10/812,359

Office Action Summary

ZENDA ET AL.

- 1) ☒ Responsive to communication(s) filed on 01 December 2006.
- 2a) ☒ This action is **FINAL**. 2b) ☐ This action is non-final.
- 3) ☐ Since this application is in condition for allowance except for formal matters, prosecution as to the merits is closed in accordance with the practice under *Ex parte Quayle*, 1935 C.D. 11, 453 O.G. 213.

Figure 9, Annotated
From Rapp (4,659,237)

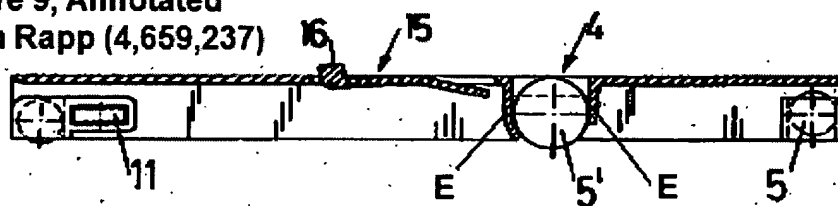
manner movable along back and forth by a floor (6) at least through a rolling supporting body (4, 5') so as to draw the object forward from a stored position in the box body (C), and characterized by that the rolling supporting body comprises a free motion rotating body (5') whose upper end makes an abutting contact with a downward facing surface (2) of the object (1) and whose bottom end contacts the floor (6), and the free motion rotating body (5') supports the front end side of the object by making a rolling movement; wherein the free motion rotating body (5') is supported by the object (1) in a manner capable of being suspended through a rail (2) and a rotor (5); wherein the rail (2) is connected to the downward facing surface of the object (1); wherein the rolling supporting body (4, 5') further comprises a bracket (4); wherein the free motion rotating body is supported by retaining means (Item E in Figure 9 Annotated); wherein the bracket (4) is connected to the rotor (5) and the rotor engages the rail (2); wherein the object (1) is a drawer (1) arranged at the lowest part of the box body (Item C in Figure 1 Annotated), said box body being a drawer storage portion. The examiner points out that, due to basic physics, the free motion rotating body (5') will obviously move at a half traveling speed of the object (1) when said object is moved horizontally.

**Figure 1, Annotated
From Rapp (4,659,237)**

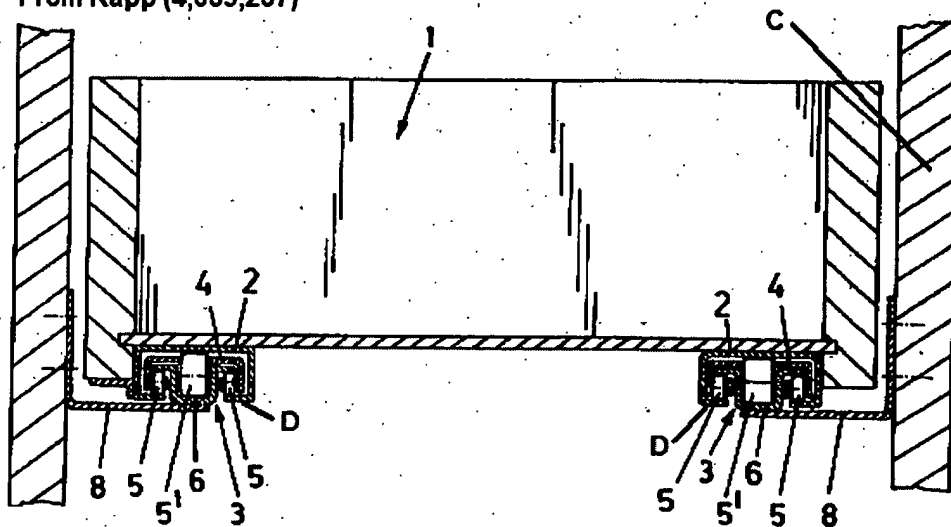
11. Rapp teaches the structure substantially as claimed, including a structure wherein at least a rear end side of an object (1) is supported in a box body (Item C in Figure 1 Annotated) in a manner movable along back and forth and a front end side of the object (1) is supported in a

15. Additionally, whereas the utilization of structures such as that taught by Rapp in desks with drawers is well-known in the art – see, for example, Grieser (5,785,400), Gutner (4,305,625), Brodbeck (2,327,761), and Harmon (2,950,158) – it would have been obvious to replace Item C of Figure 1 Annotated with a drawer storage portion of a desk in order to provide structural support to a desk drawer while preserving the horizontal mobility thereof, thereby providing the structure substantially as claimed.

Figure 2, Annotated
From Shapleigh (3,613,566)

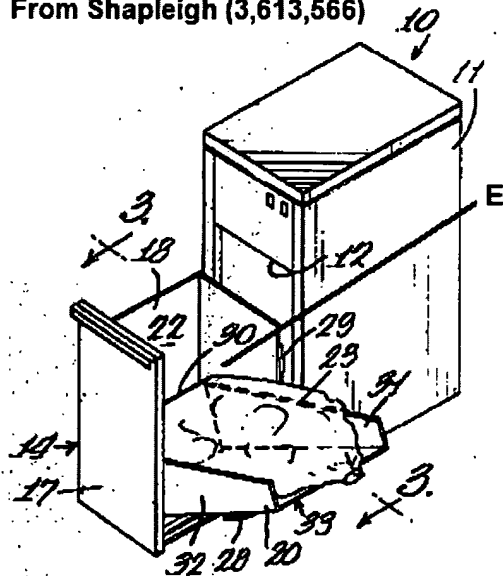
16. Claims 16 and 17, as best understood, can be alternately rejected under 35 U.S.C. 103(a) as being unpatentable over Rapp (4,659,237) in view of Ronda (EP 439,774), further in view of Shapleigh (3,613,566). Rapp and Ronda teach the structure substantially as claimed, including a drawer (1) arranged at the lowest part of the drawer storage portion (Item C in Figure 1

Annotated); the only difference being, Rapp and Ronda fail to teach a drawer that has an arrangement in which each upper part of three sides of a bottom wall is surrounded by a standing wall and an upper part of one side thereof that is orthogonal to a direction accessible to an article to be stored is open. Shapleigh, however, teaches a drawer (22) that has an arrangement in which each upper part of three sides of a bottom wall (21) is surrounded by a standing wall (17, 18, 19) and an upper part of one side (Item E in Figure 2 Annotated) thereof that is orthogonal to a direction accessible to an article to be stored is open. It would have been obvious to one of ordinary skill in the art to replace the drawer in the structure of Rapp with the drawer taught by Shapleigh in order to provide easier access to the objects contained within said drawer, thereby providing the structure substantially as claimed.
